F-Sport Front Sway Bar Thump Noise

Service Category Suspension

Section Front Suspension

Figure 1.

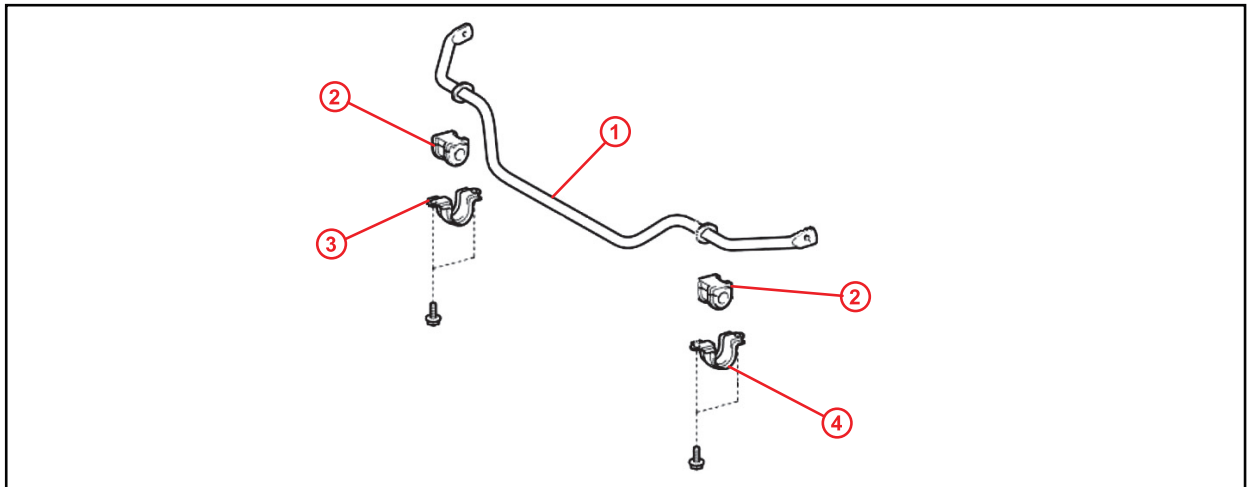
The revised bushings are identified with a “ZD” marking, and the original bushings are identified with an “AB” marking.

1. Replace the sway bar bushings.
